**FINAL**

**MITIGATED NEGATIVE**

**DECLARATION**

**ALVERNO HIGH**

# Landscape Concept of Parking Lot at Michillinda Avenue

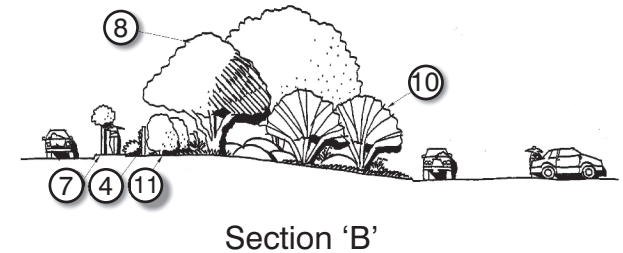
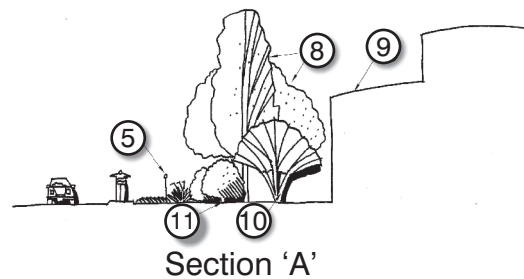
- R18-19 The comment concerns noise and light intrusion associated with new tubular fencing at the Michillinda parking lot. The tubular fencing would be installed on the perimeter of the lot along Michillinda Avenue. The existing six-foot-high wall along Grandview Avenue would remain. Both noise and light impacts associated with the Michillinda parking lot were studied in the Draft MND. As described in section 3.1(d) of the Draft MND, compliance with lighting requirements, as specified under Section 17.68.120 of the Sierra Madre Municipal Code, would reduce lighting impacts to an insignificant level. Additionally, as illustrated in Figure 14 of the Draft MND, noise levels generated from the lot would not be significant.

Additionally, as discussed in General Response #1, the proposed project does not need to analyze existing impacts associated with operation of the Villa. Impacts to noise, traffic, and aesthetics are addressed in the preceding responses to this comment letter.
